Record of Decision

General Electric Main Plant Site

Operable Units No. 03 and 04

March 2005

FIGURE 17

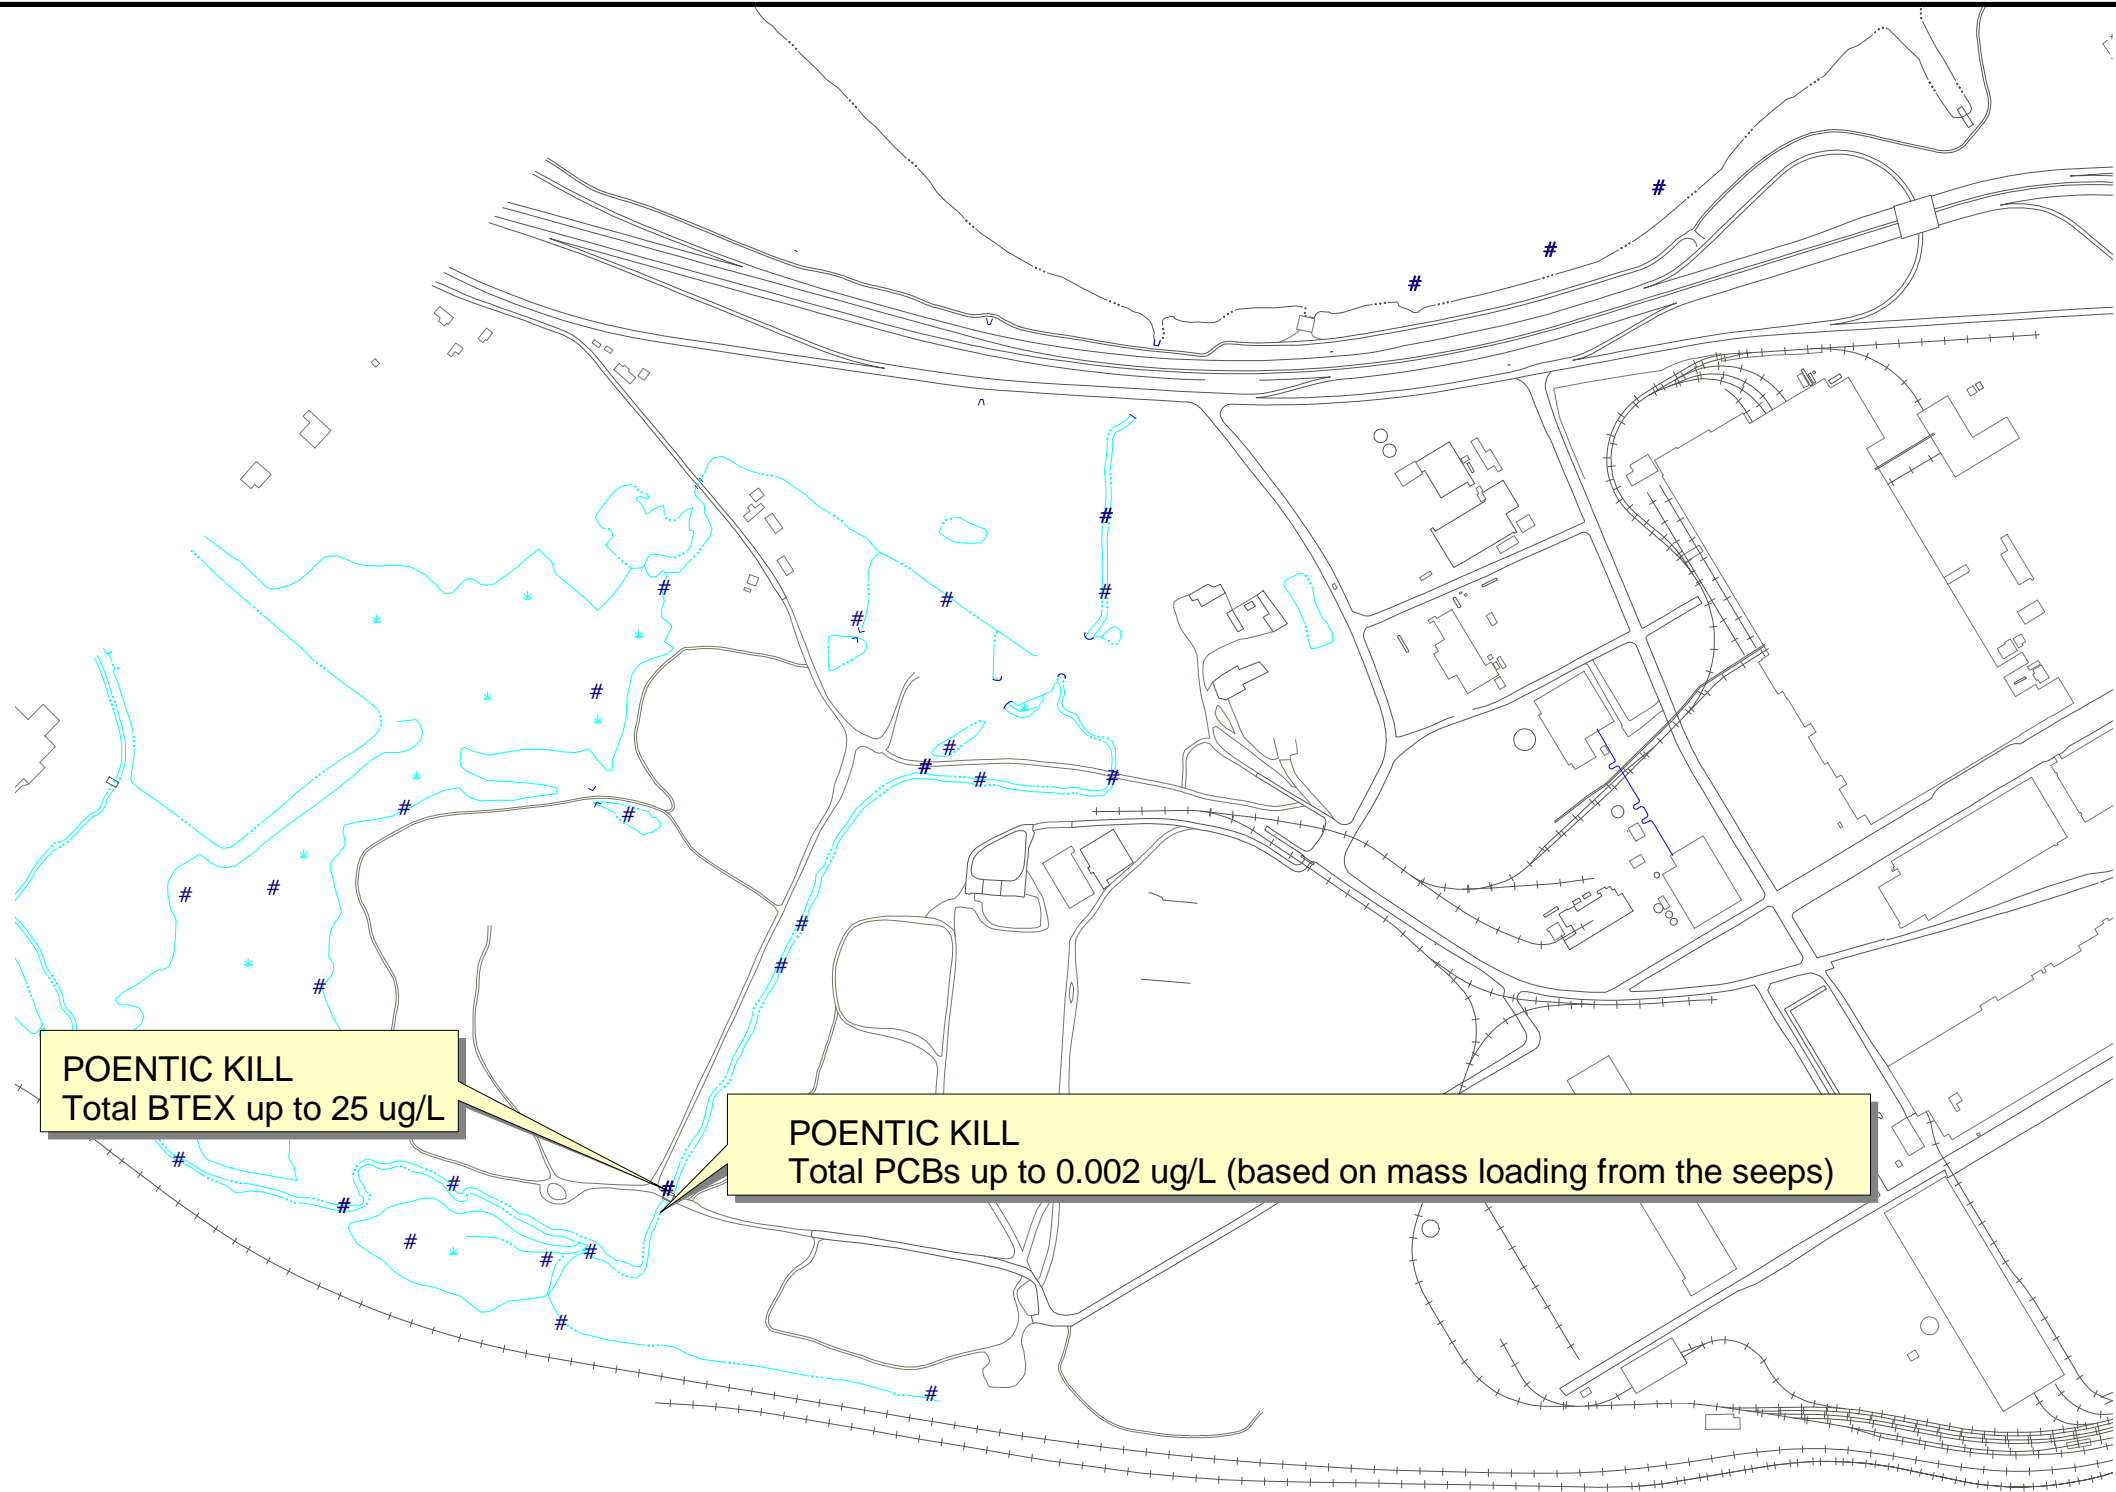
Comment 52: *Page 3, 3rd Paragraph - The PRAP on page 14 states that the extent of the ground-water contamination in the fill/flood plan and channel-fill aquifers is shown in Figures 16 and 17. We do not find it clearly shown and would like more in depth proof of the extent of the ground water contamination.*

Comment 57: *Page 2, 2. - Given the alarmingly high level of VOCs at the Wire Mill Site (fig 17), was there not some attempt to define the extent of the likely plume of VOCs by drilling and sampling additional wells?*

Response 56: The intent of the figures (16 & 17) included in the PRAP were to provide a general, high-level summary of the multitude of investigative data and results from the RI program. Specifically, Figures 16 & 17 illustrate the locations and results of higher concentrations of contaminants detected during the RI program including representative locations within the groundwater for the corresponding geologic depositional layers. For a detailed summary of detected and non-detected constituents, including better illustrations of sampling locations, please refer to the *Revised RI Report*.

FIGURE 10	GEOLOGIC CROSS-SECTION EAST/WEST
GENERAL ELECTRIC COMPANY MAIN PLANT, SCHENECTADY, NEW YORK	
URS CORPORATION 646 PLANK ROAD, SUITE 202 CLIFTON PARK, NEW YORK 12065

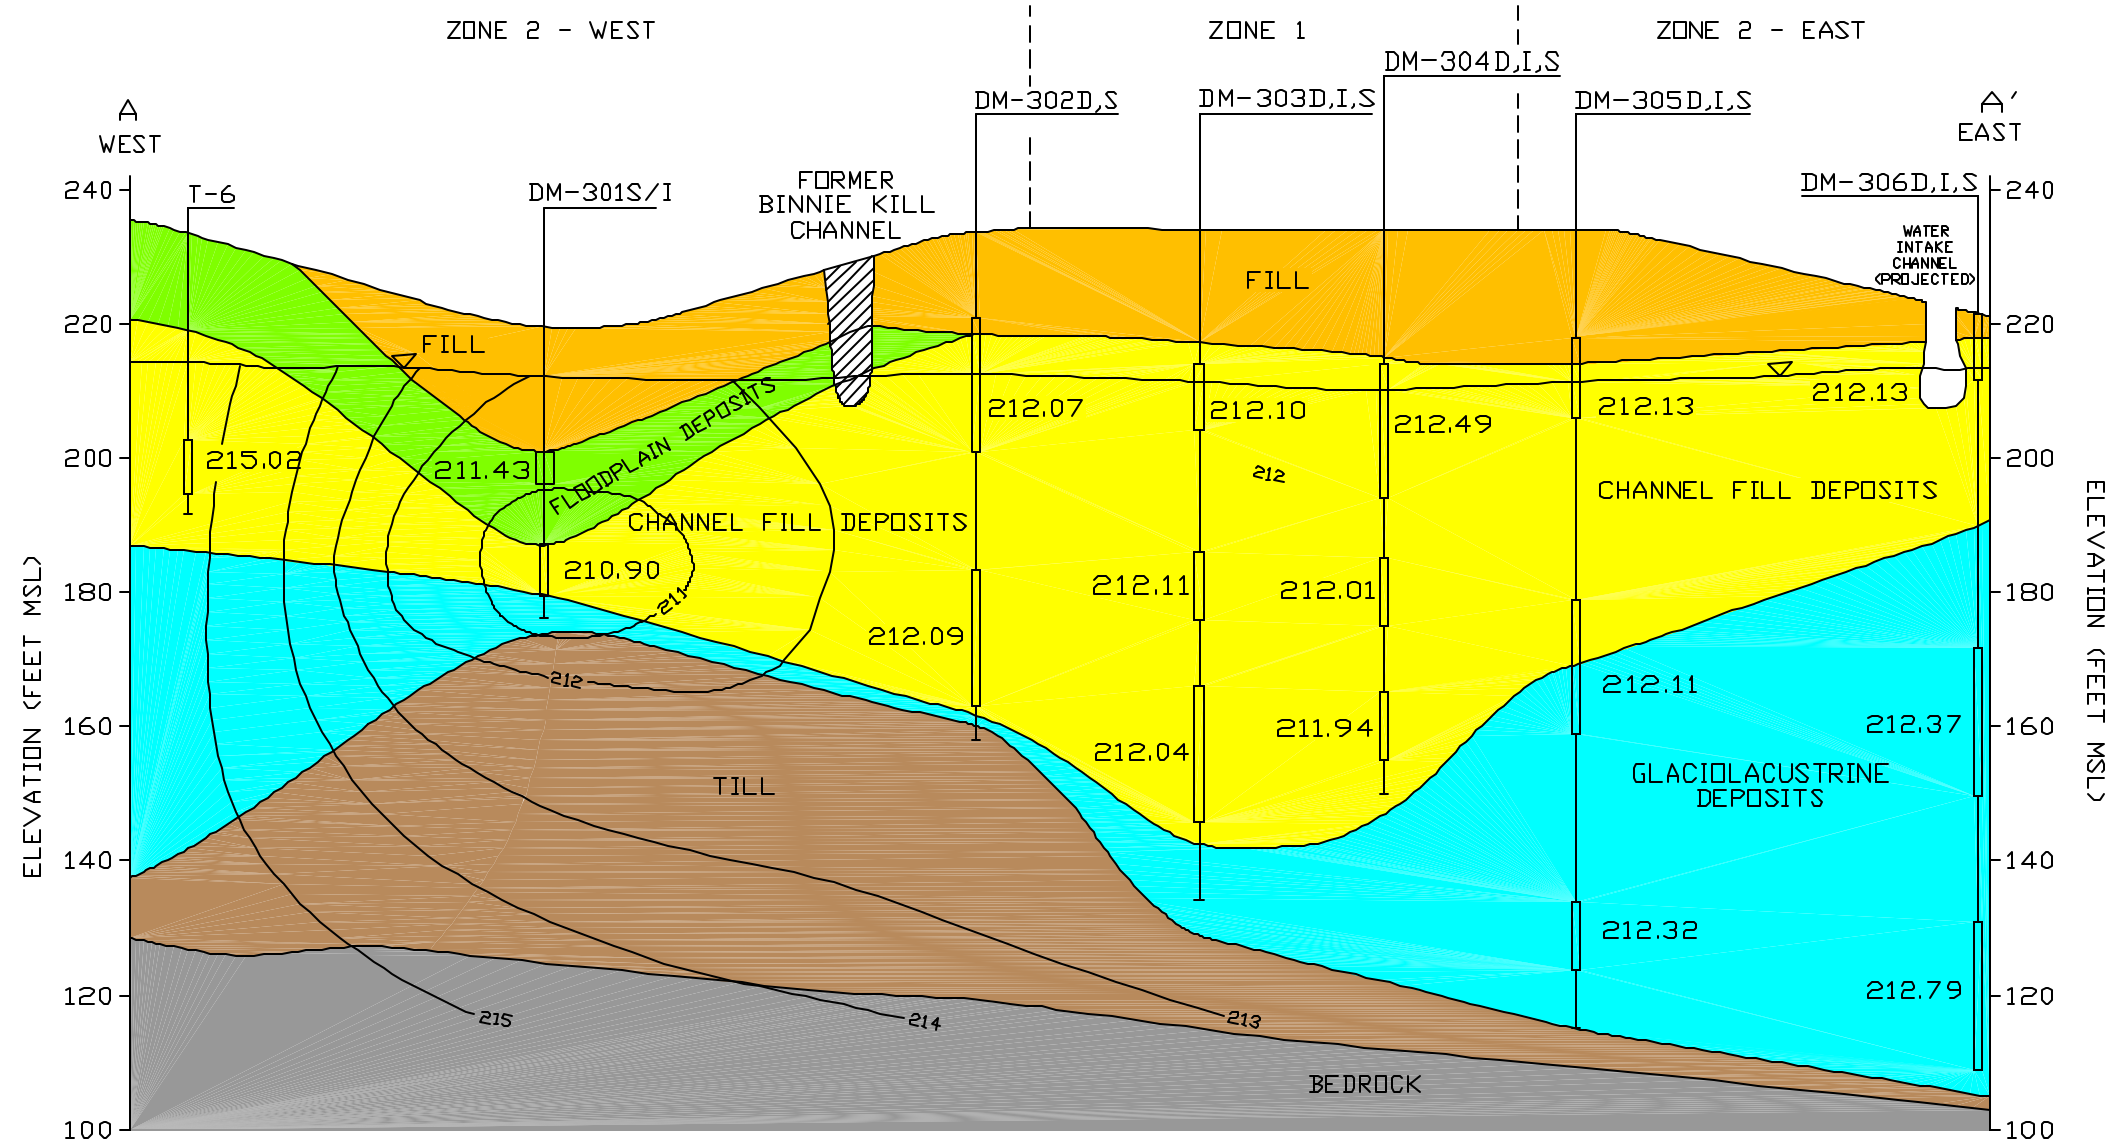
Comment 51: *Page 3, 2nd Paragraph - Figure 10 of the PRAP depicts a continuous gravel aquifer extending westward to Campbell Road. Where is the evidence that more test holes were drilled west of Campbell Road to confirm existence of the “channel-fill aquifer”?*
